SITE PLAN APPLICATION

NAME OF PROPOSED DEVELOPMENT Timber-trail
ROCKWALL PLAZA

TO: KAREN MARTIN
FROM: LARRY KING
DATE: OCTOBER 27, 1983
SUBJECT: TIMBER TRAIL PLAZA REVIEW

PLANNING AND ZONING COMMISSION
SITE PLAN FACT SHEET

SITE PLAN SECTION

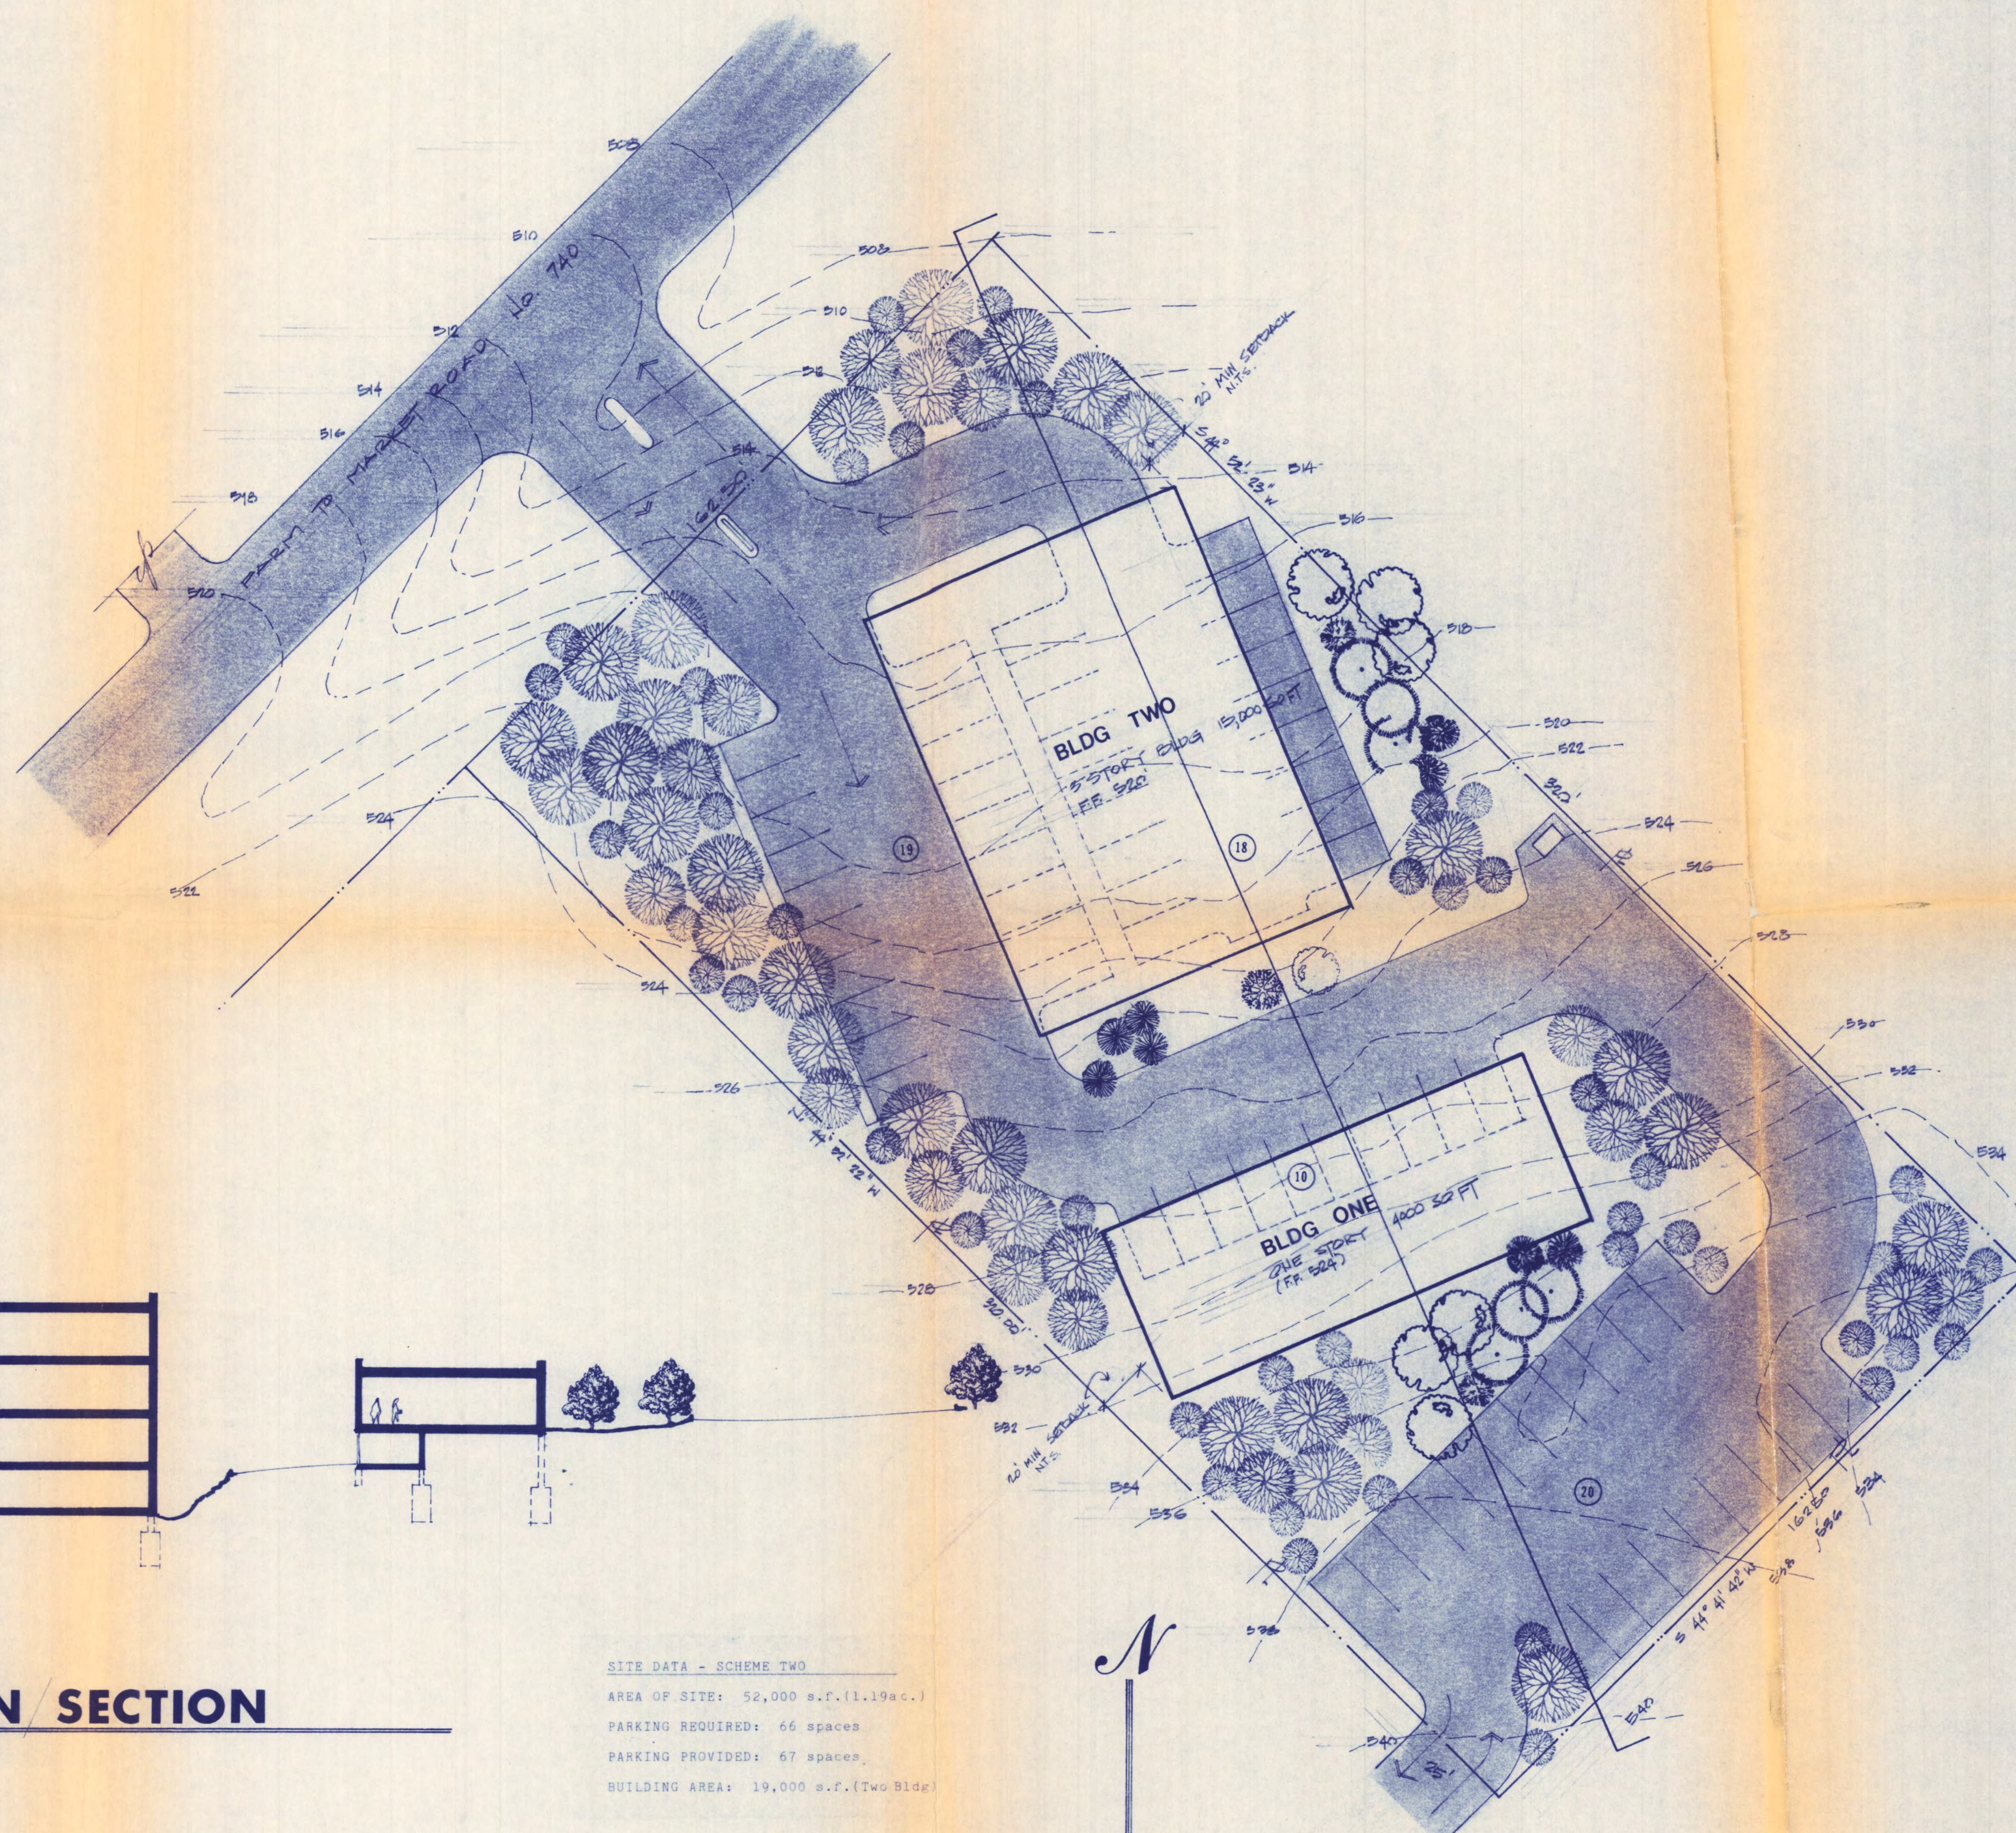
Staff Comments: Adequate parking, front and rear access and ~~setback~~.
Larry King will review with City Building Codes.
Violates side setback unless walls are 1 hour fire
retardant.

Building #1 violates Section 2.12, F-5, which regulates side setbacks. The submitted plans call for a 10'6" minimum setback, which by the above Section is not allowed because 15' is the least amount allowed, unless adjoining wall is one hour fire retardant.

Building Code also regulates by Table 5-A a minimum side setback of 20' from any property line, unless protected by one hour fire retardant wall 10' from any property line.

Approval subject to meeting side yard setback requirements.

SITE DEVELOPMENT PLAN
 SCALE: 1" 20'-0"
 SITE DATA
 Area of Site: 52,000 square feet (1.194 acres)
 Parking Spaces: (75) need 77
 Building Area: 22,500 square feet

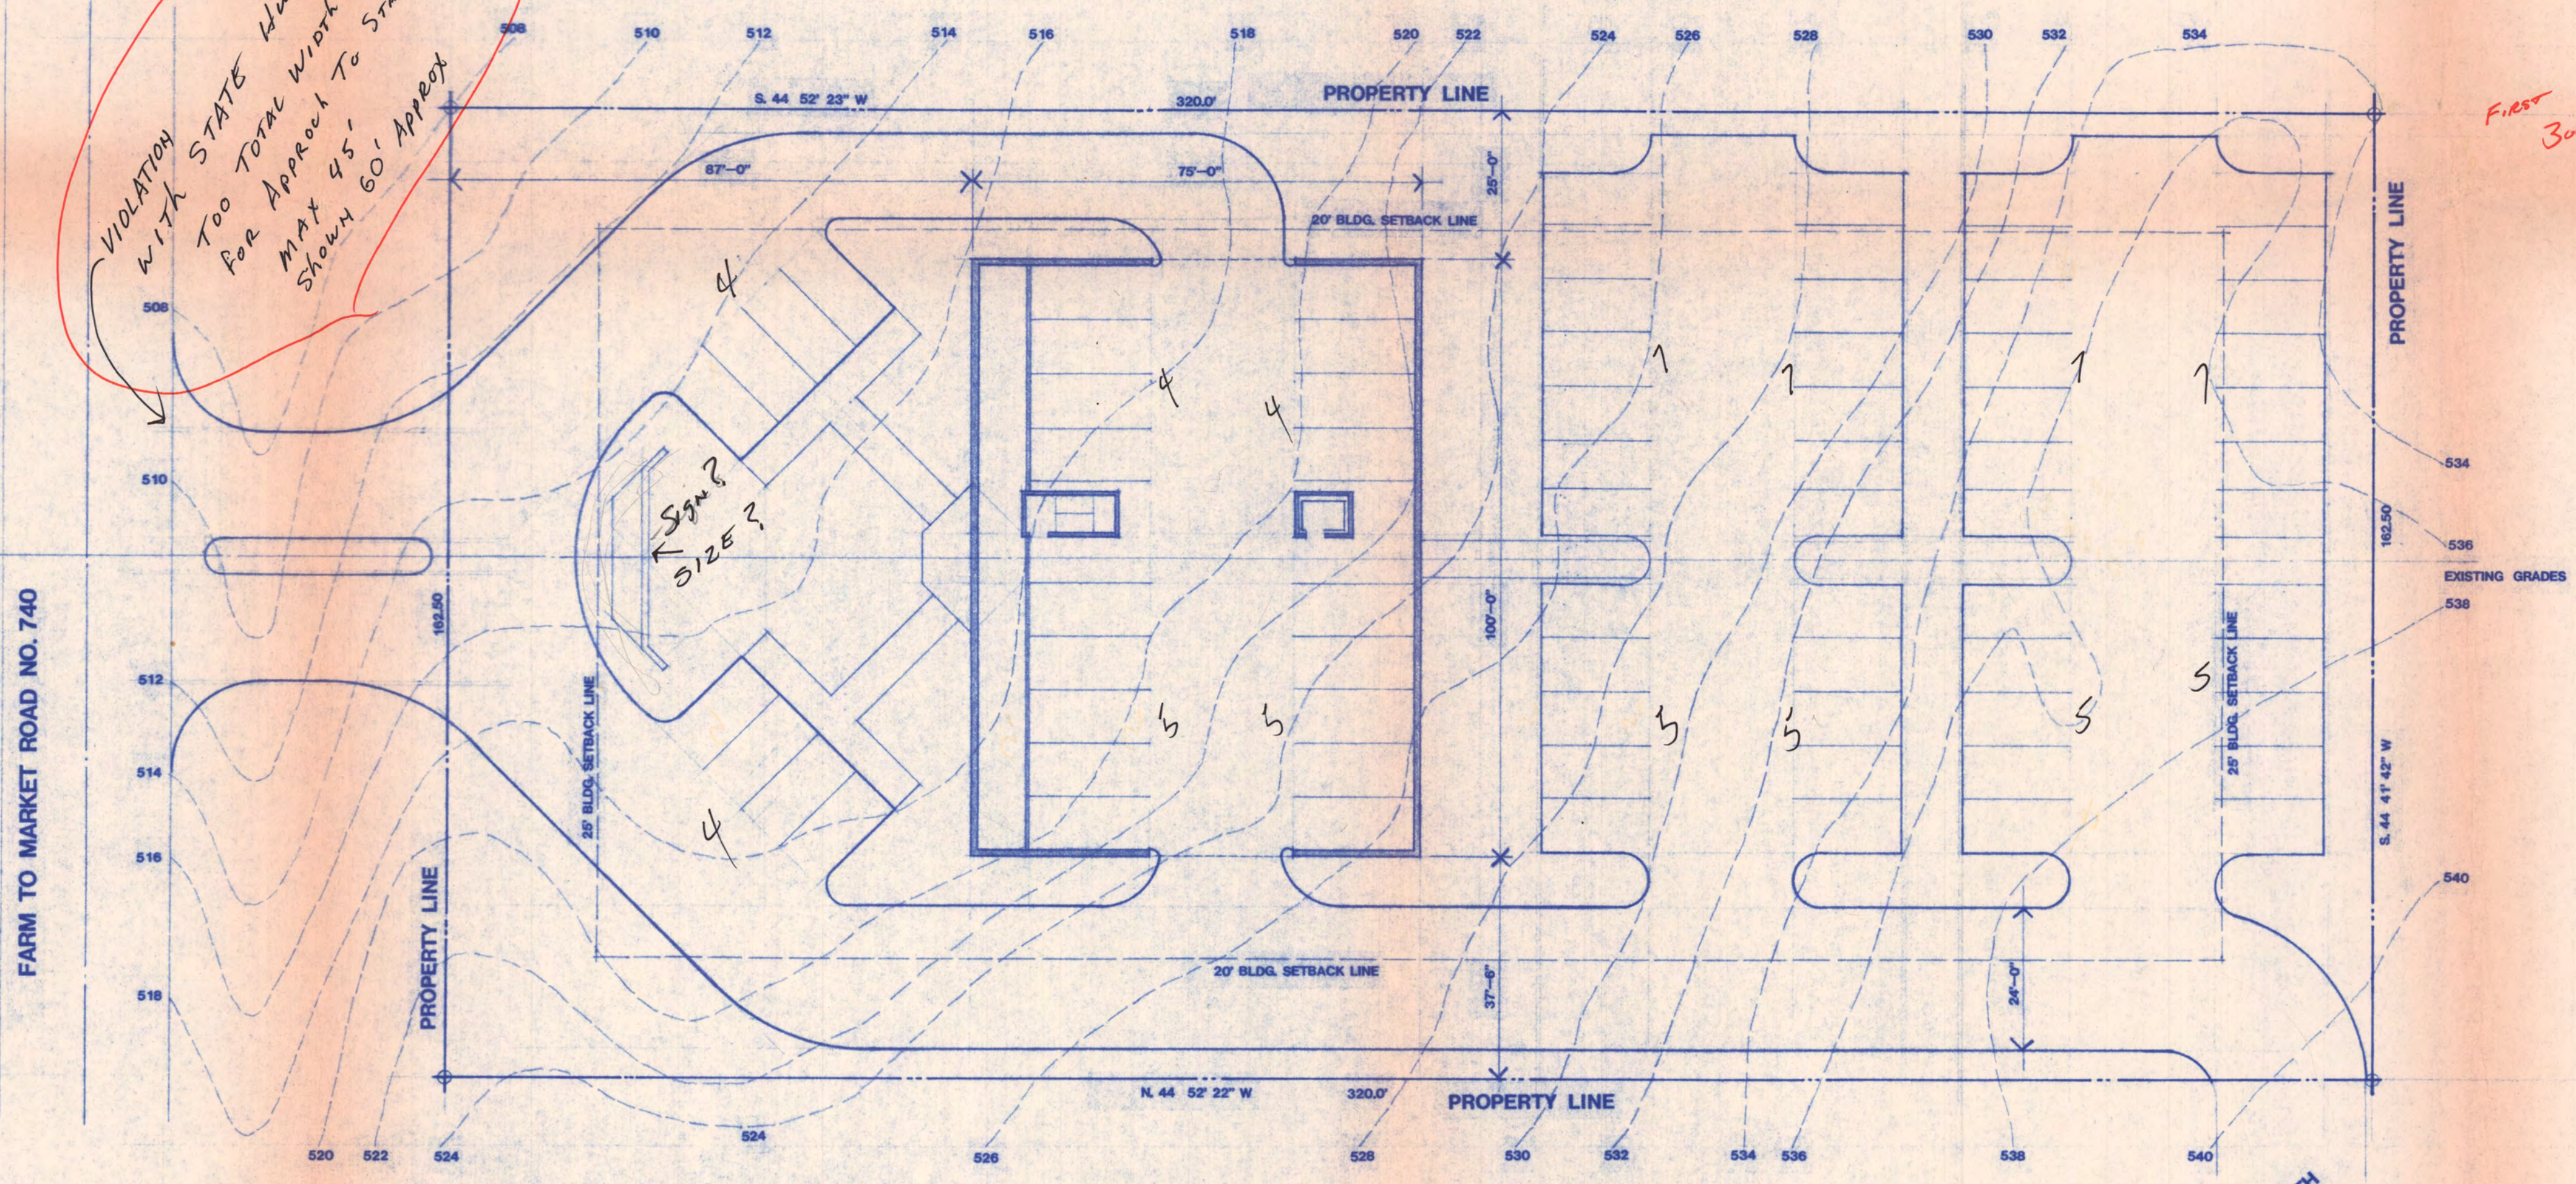
A. Indicates a drive approach of approximately sixty (60) feet in width. State Highway Regulations require an approach of under 45 feet maximum.

2. Parking shown does not comply with the current zoning ordinance. The ordinance requires three parking spaces for first 300 square feet of building area, with an additional space for each additional 300 square feet. The total building area of three floors totals 22,400 square feet, which requires a minimum of 77 spaces. The submitted plan on page one indicates only 74 parking spaces.

PARKING REQ. = 77 SPACES for a total of 22,500 sq ft
Parking Shown = 75 SPACES

$$\begin{matrix} 22,500 \\ - 300 \\ \hline 22,200 \end{matrix} = 79$$

$$79 - 2 = 77 \text{ NEEDED}$$

VIOLATION STATE Hwy Reg. Too Total width Allowed For Approach To State Road MAX 45' SHOWN 60' APPROX

11/10/83 - Approval with a total of 77 parking spaces and review of entrance width.

12/5/83 - Approve with 77 spaces and width of entrance dependent on Highway Dept. variance.

FIRST FLOOR PLAN
SCALE: 1/8"=1'0"

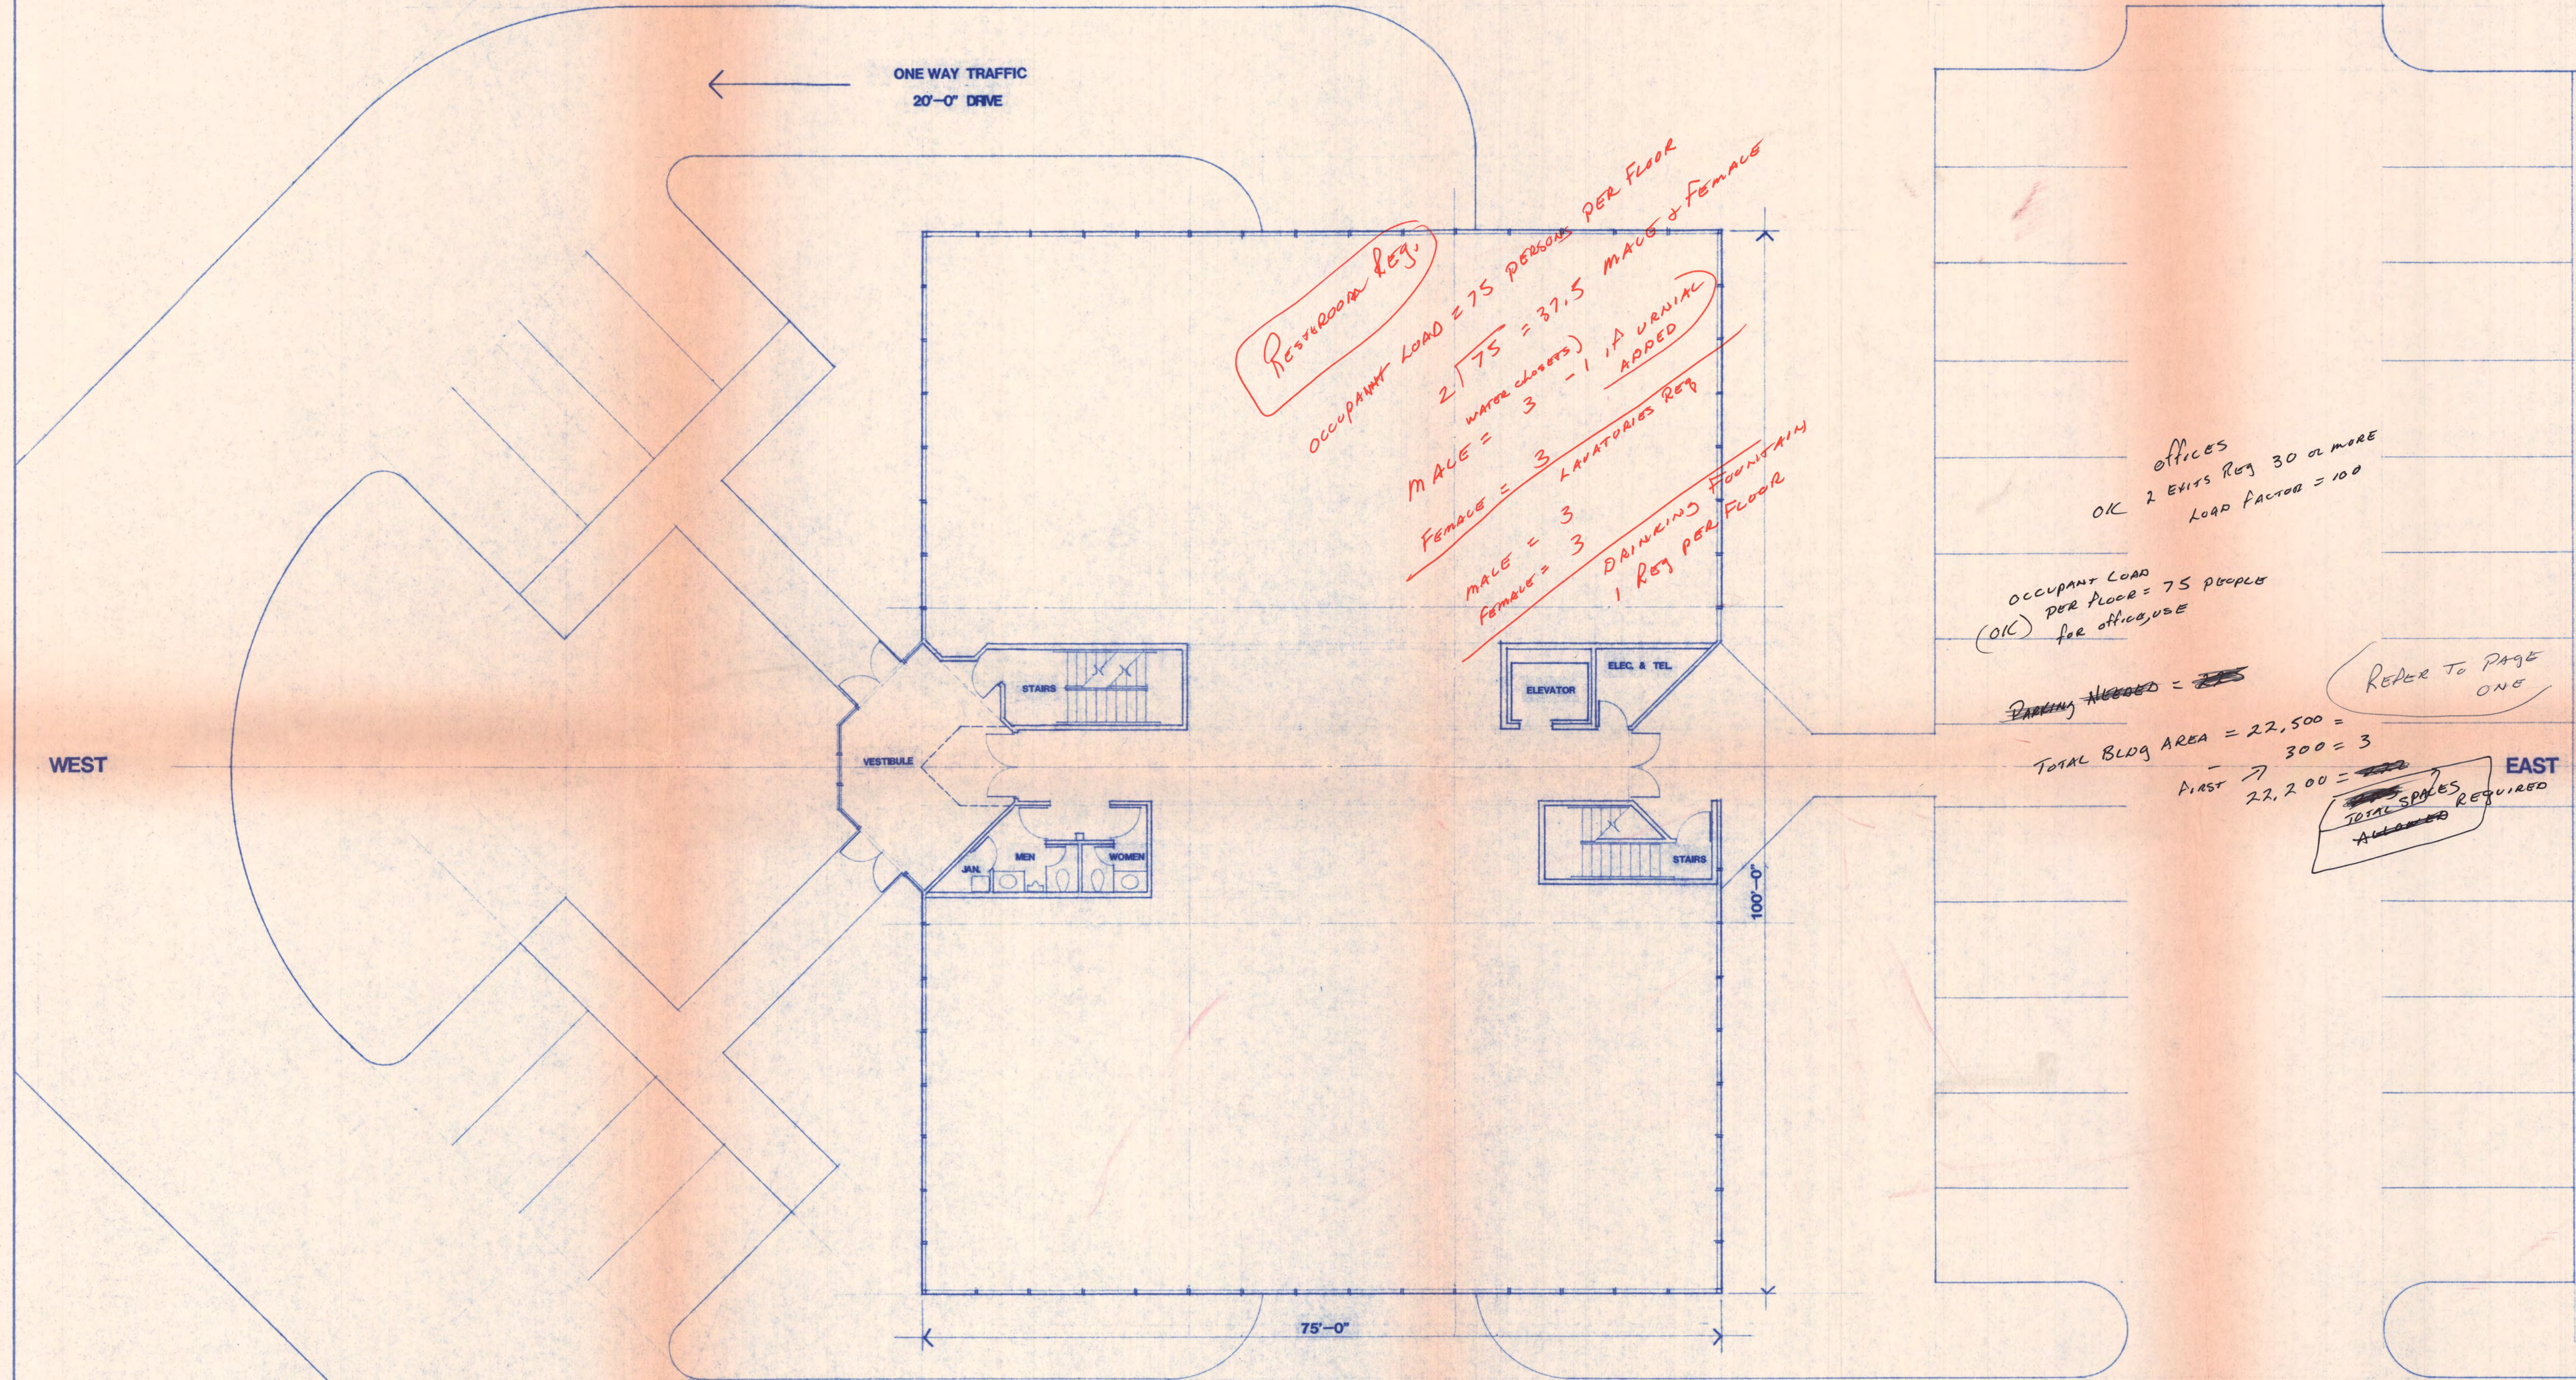
A. Indicates the proposed restroom design, which design indicates two separate restrooms with one water closet for each sex, and one lavatory per sex unit. The following indicates the required design by code:

WATER CLOSETS REQUIRED PER FLOOR

Male = 3/may subtract one (1) if urinal installed

Female = 3

LAVATORIES PER FLOOR

Male = 3

Female = 3

DRINKING FOUNTAINS REQUIRED

One (1) per floor

Restroom Req.
OCCUPANT LOAD = 75 PERSONS PER FLOOR
2 / 75 = 37.5
WATER CLOSERS
MALE = 3 - 1 IA URINAL ADDED
FEMALE = 3 LAVATORIES REQ
MALE = 3 DRINKING FOUNTAIN
FEMALE = 3 1 REQ PER FLOOR

offices
OK 2 EXITS REQ 30 or MORE
LOAD FACTOR = 100
OCCUPANT LOAD
(OK) PER FLOOR = 75 PEOPLE
for office use
